BELT LINE STORM SEWER

STORM SEWER PLAN & PROFILE

SUITES OF AMERICA
TOWN OF ADDISON
DALLAS COUNTY, TEXAS

3711-77 Belt Line Shopping Center

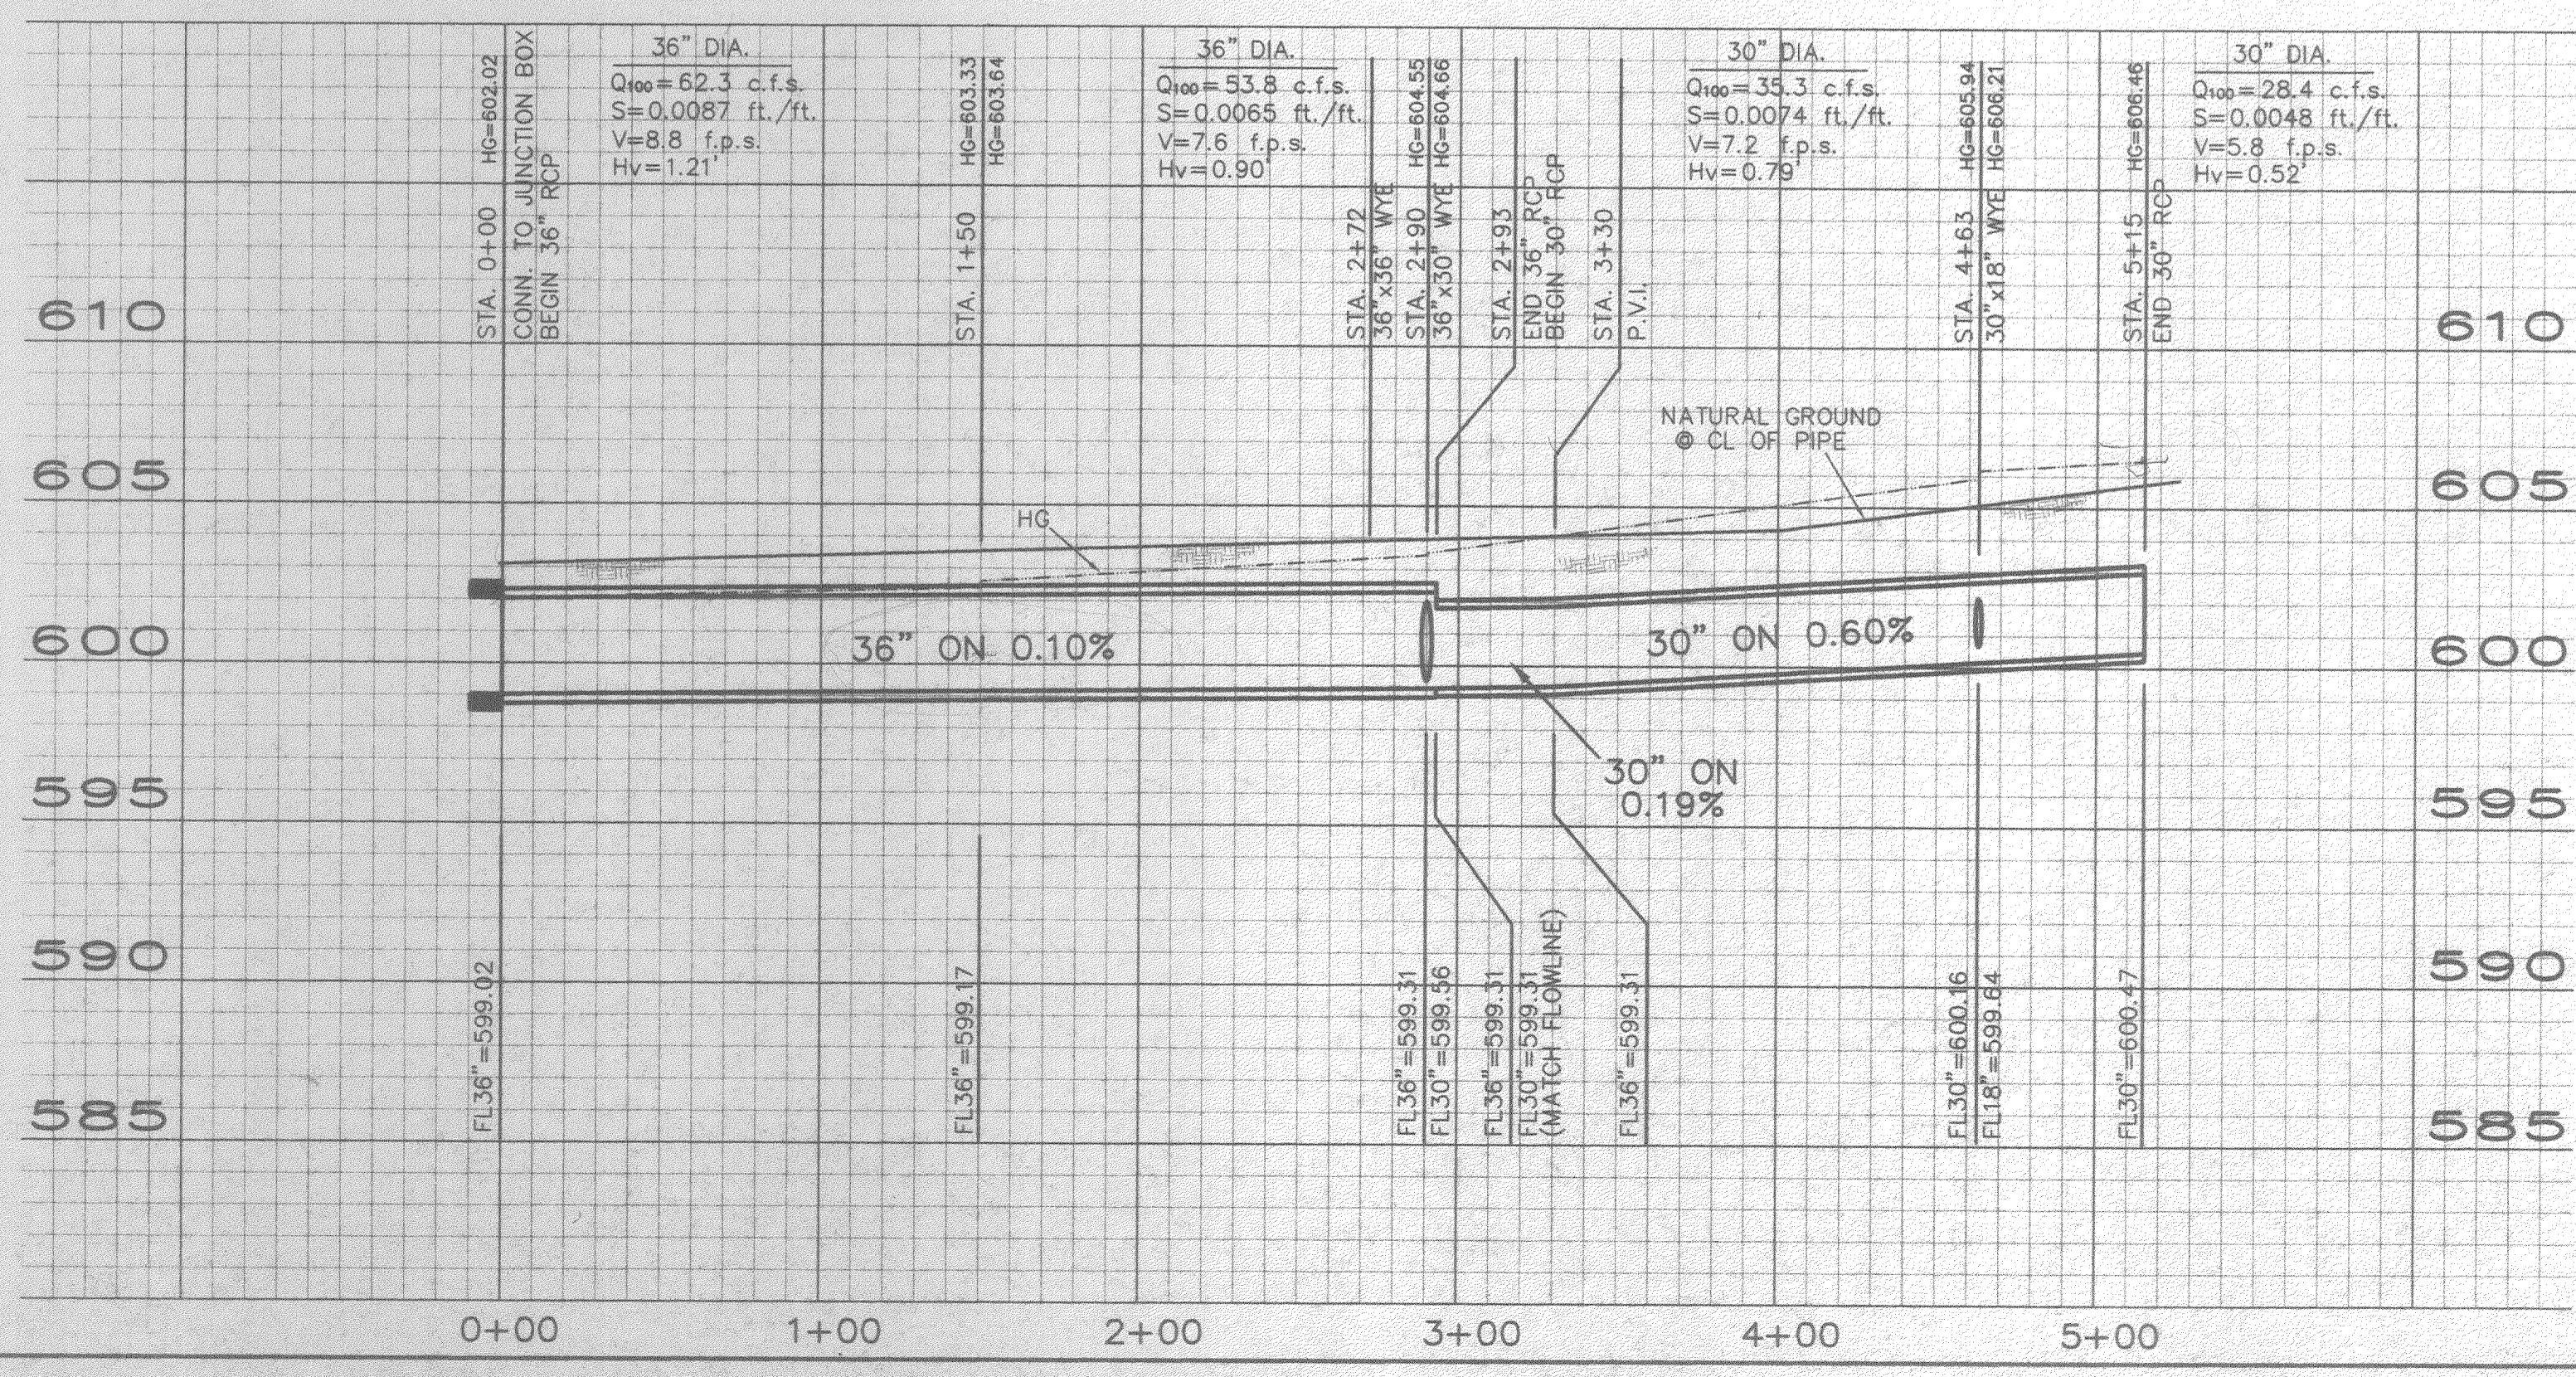
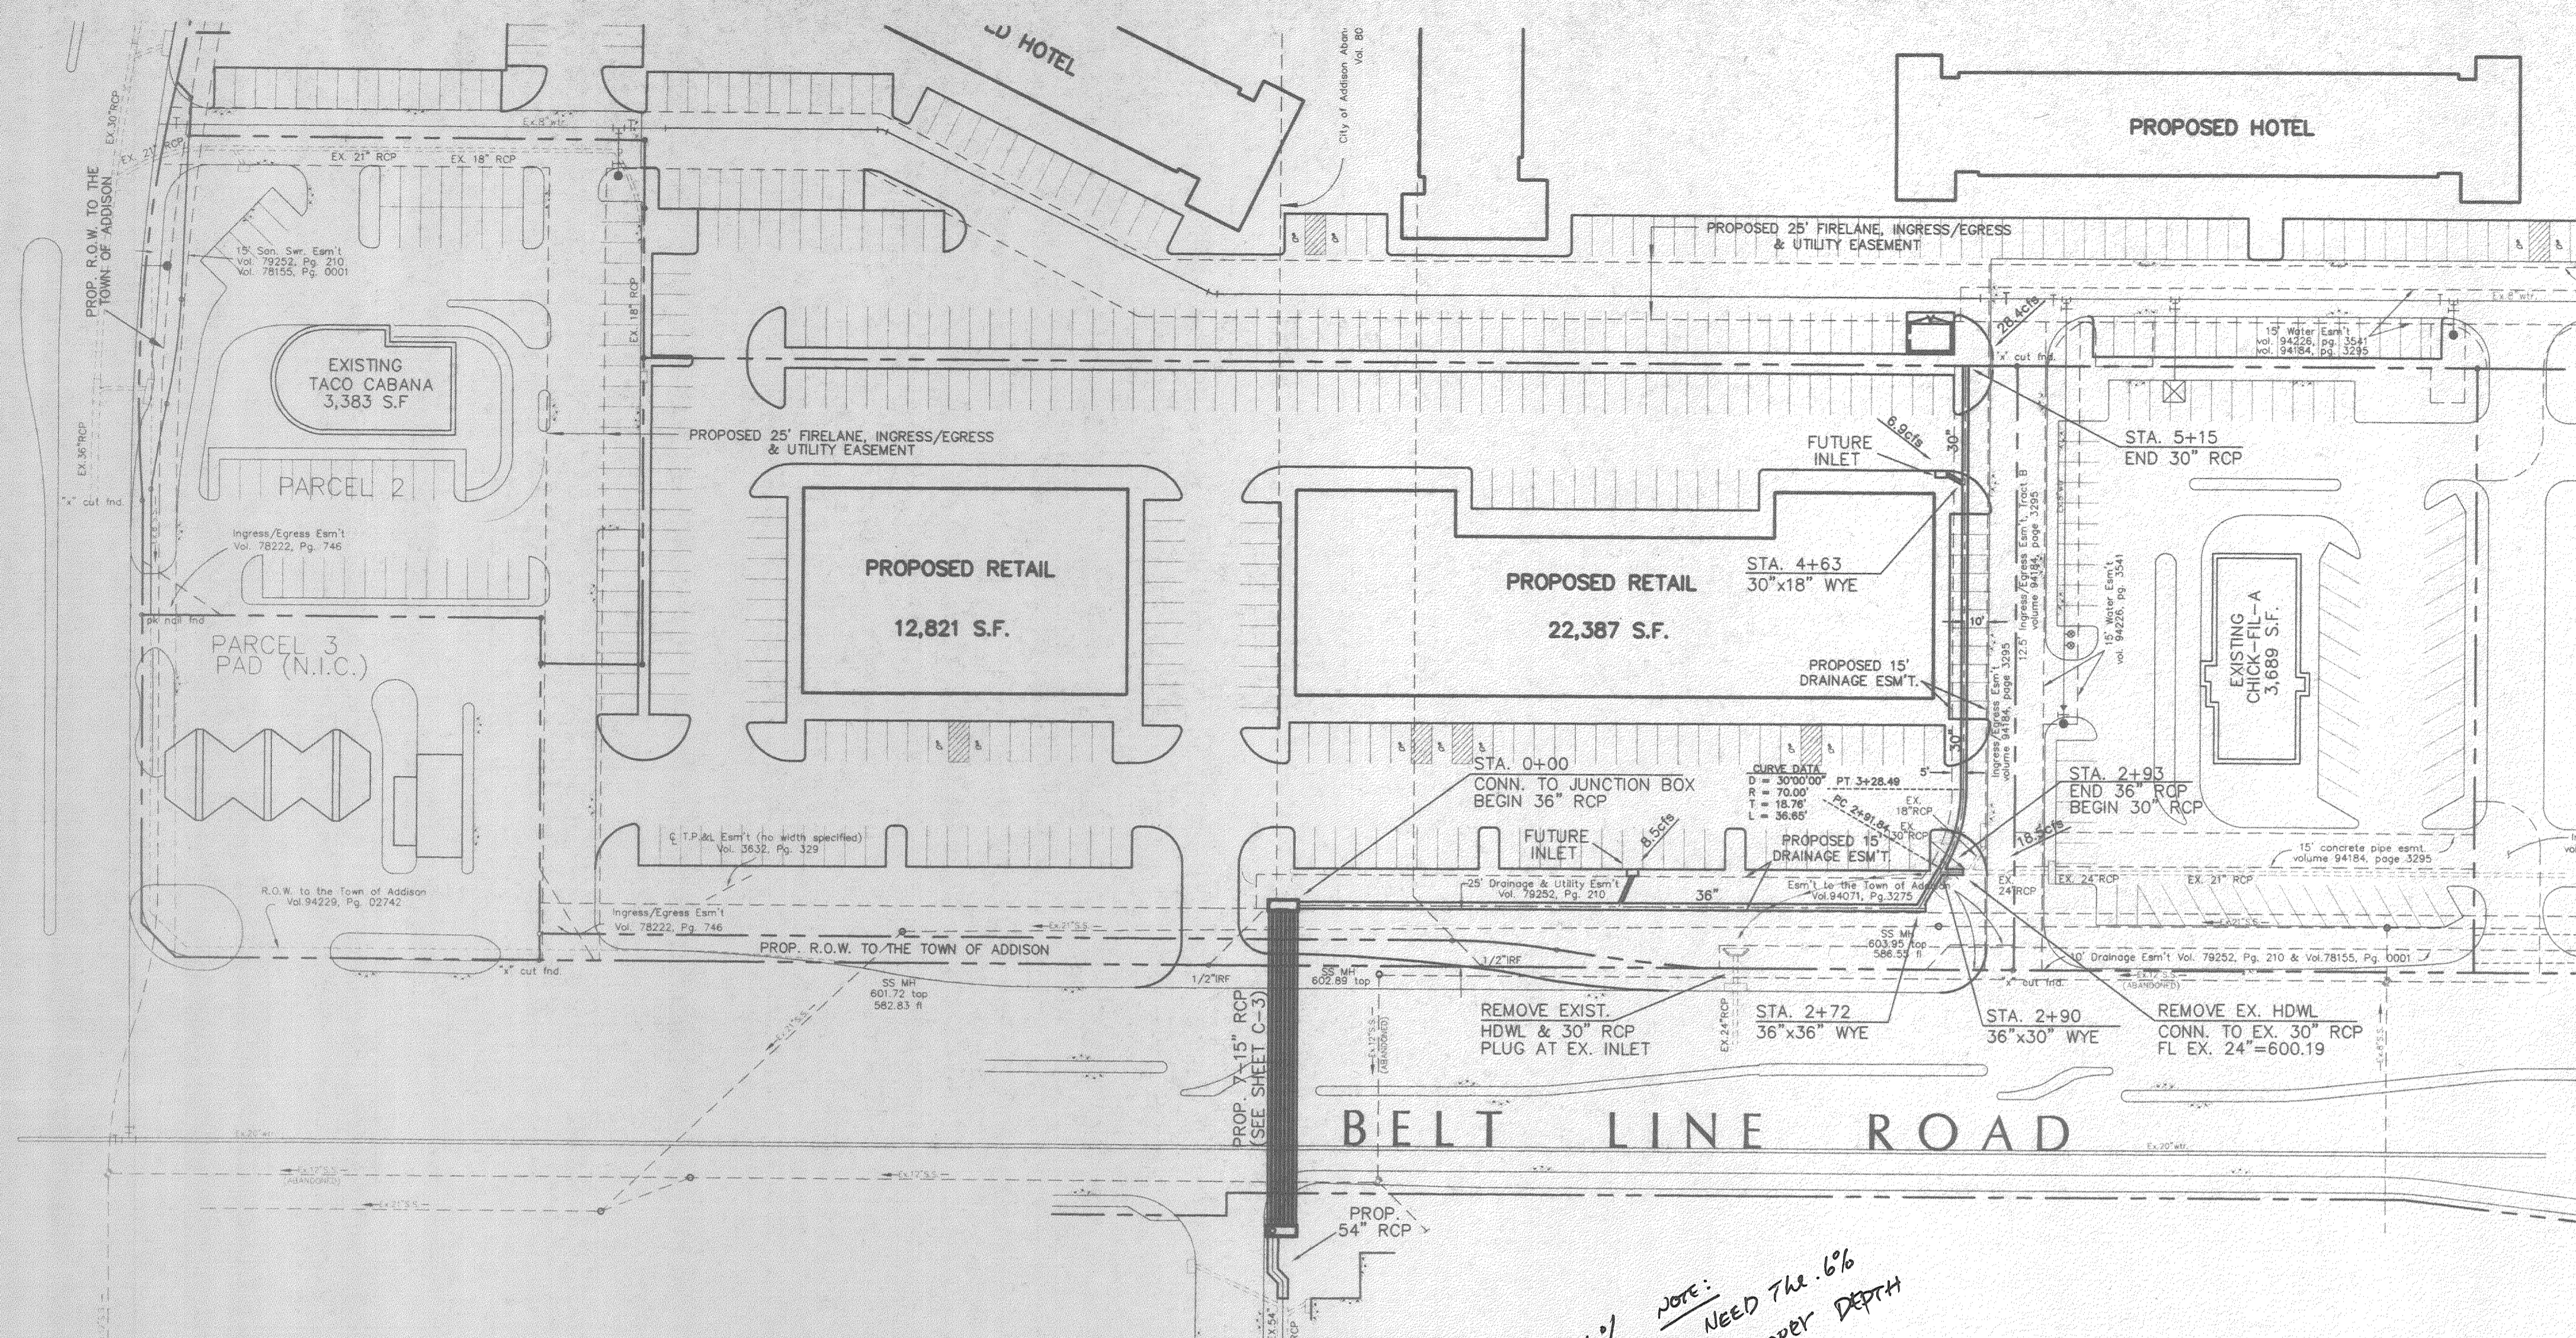
36" on .19% = 70 c.f.s.

30" on .6% = 104 c.f.s.

NOTE: NEED THE .6% SLOPE TO GET PROPER DEPTH

DIFFERENCE IS OK BECAUSE 70 c.f.s. falls betw Q_{min} of 62.3 etc

4/12/99 REVISED PROFILE
